10-26-77
 John,
 for your
 preliminary review of
 contact you about floor plans
 Jerry M. Williams
 PH 243-7441

RAWLS & WELTY
 ARCHITECTS/PLANNERS
 4825 LBJ Fwy, Suite 225
 Dallas, Texas 75234

JOB NO. 1807
 DATE:
 SHEET NO.

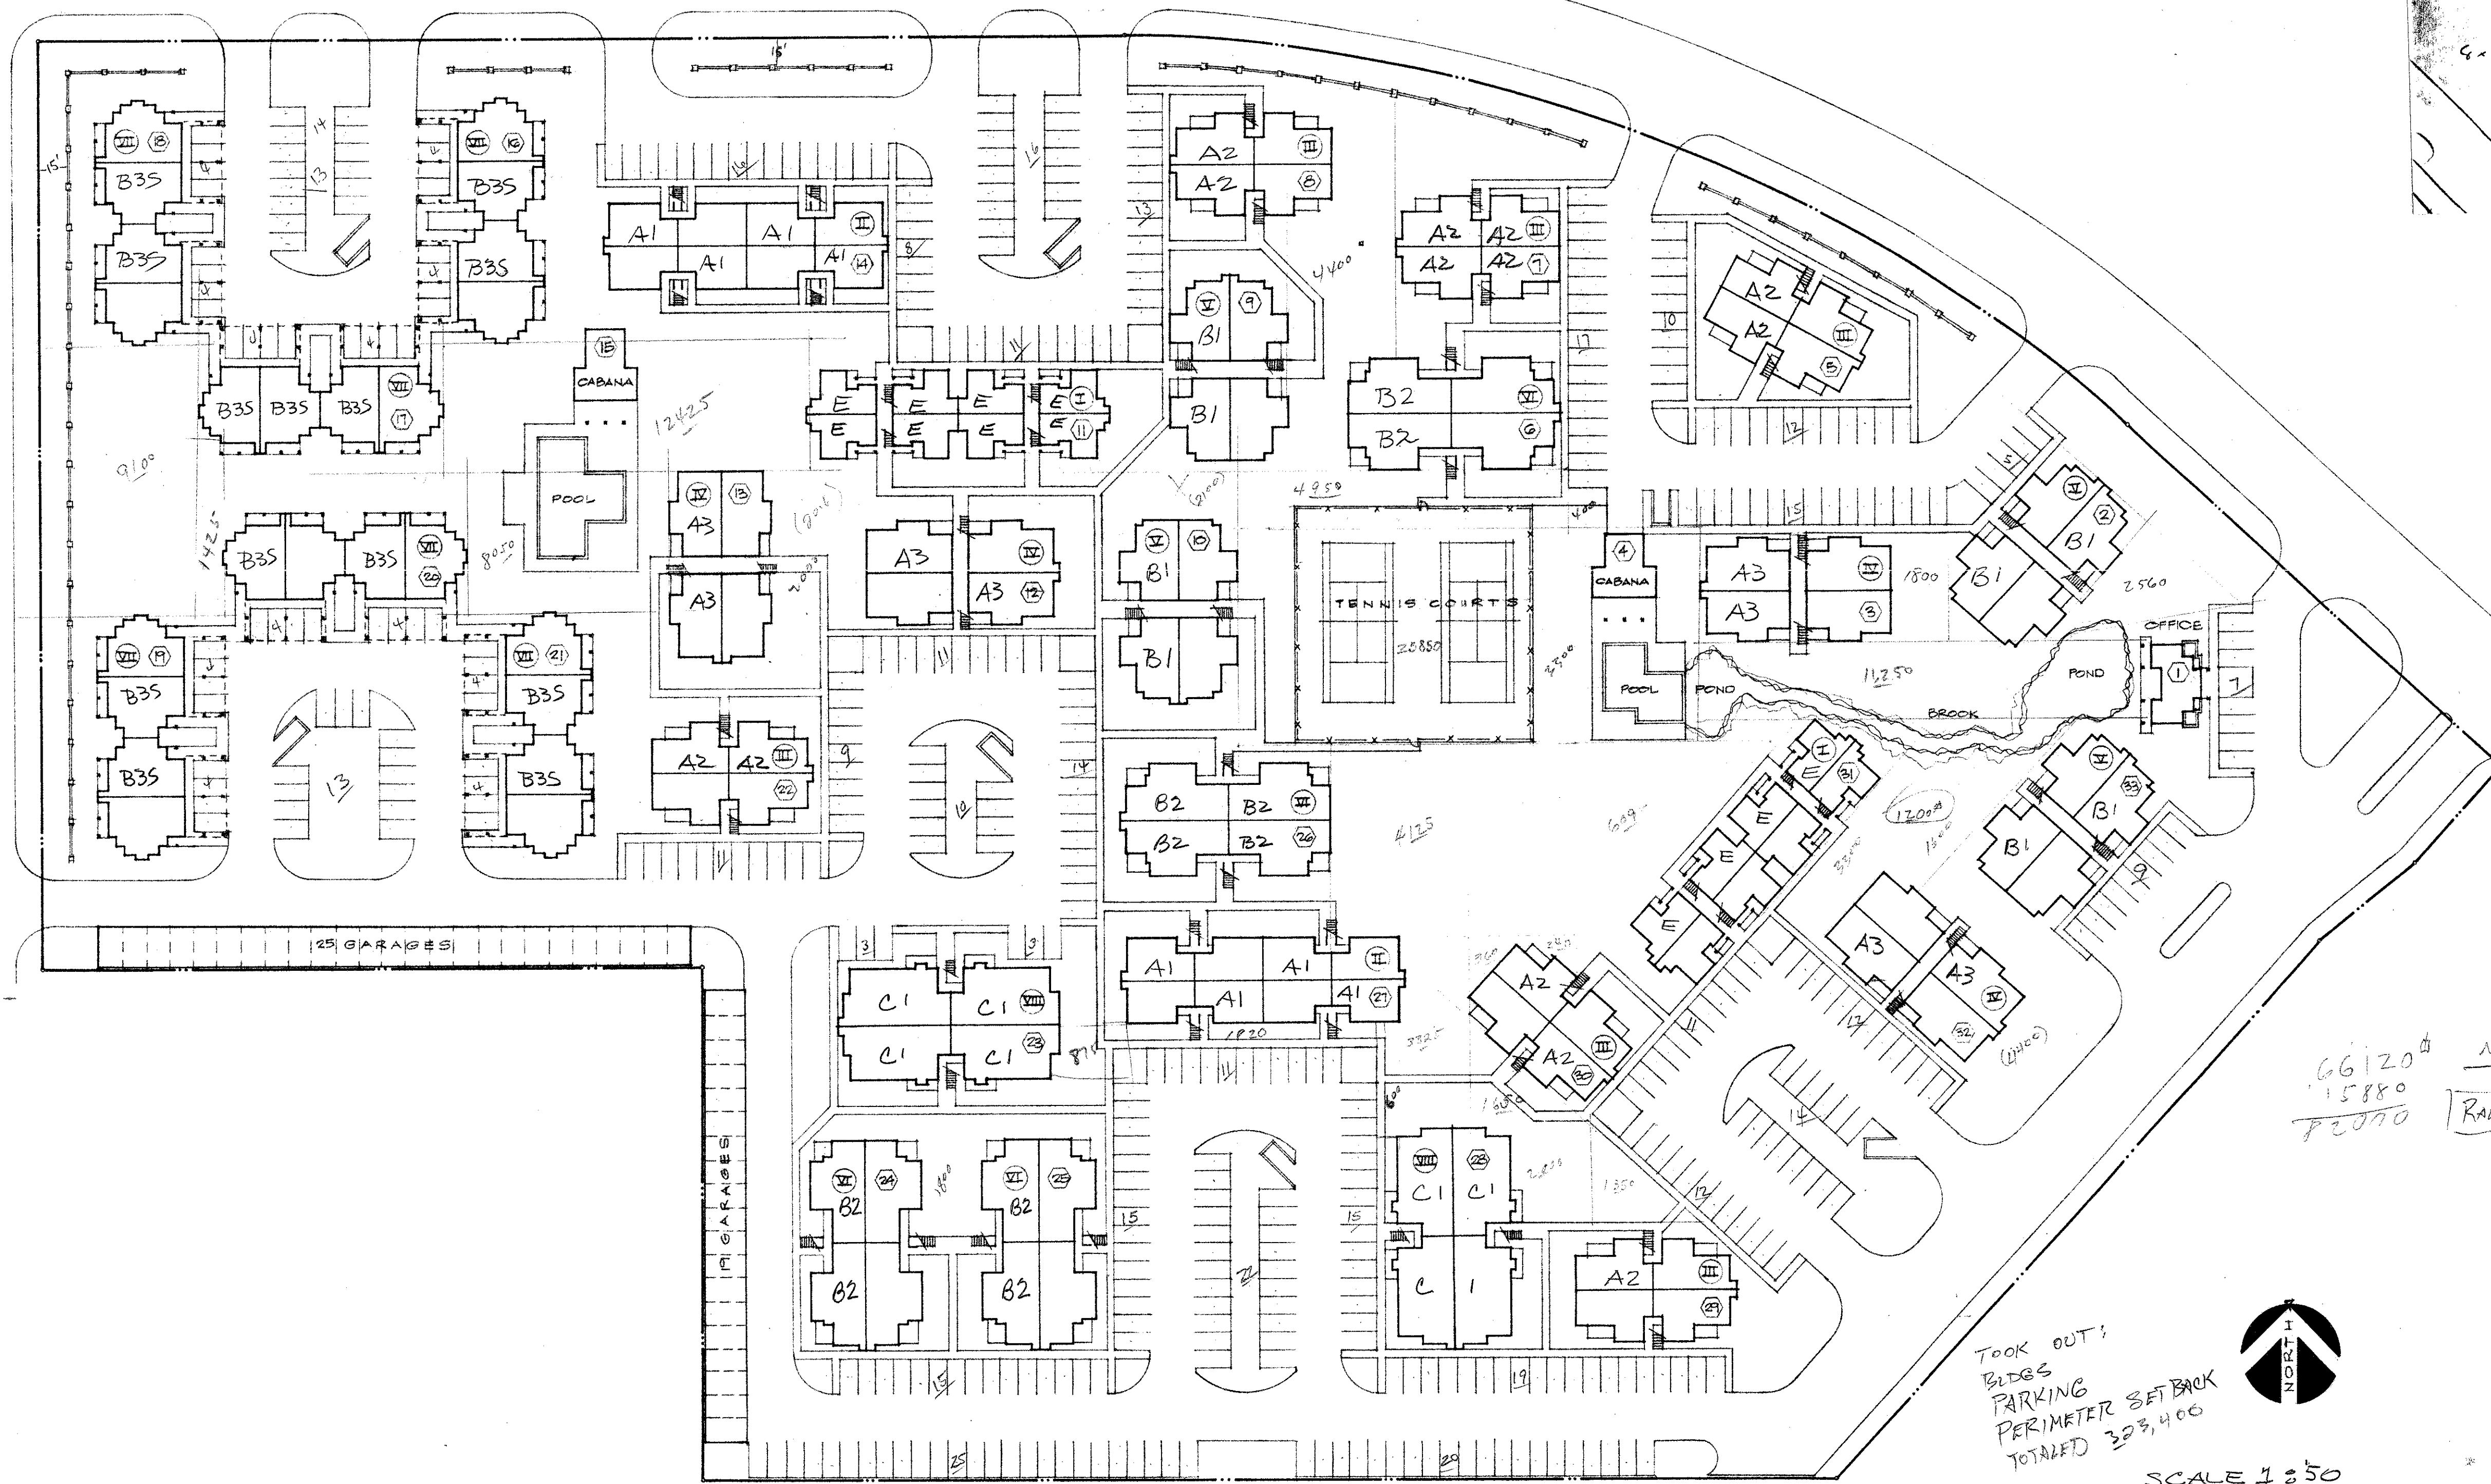
66120
 5880
 72000
 NEED 09200
 RAWLS

Took out:
 Bldgs
 Parking
 Perimeter setback
 Totalled 303,400
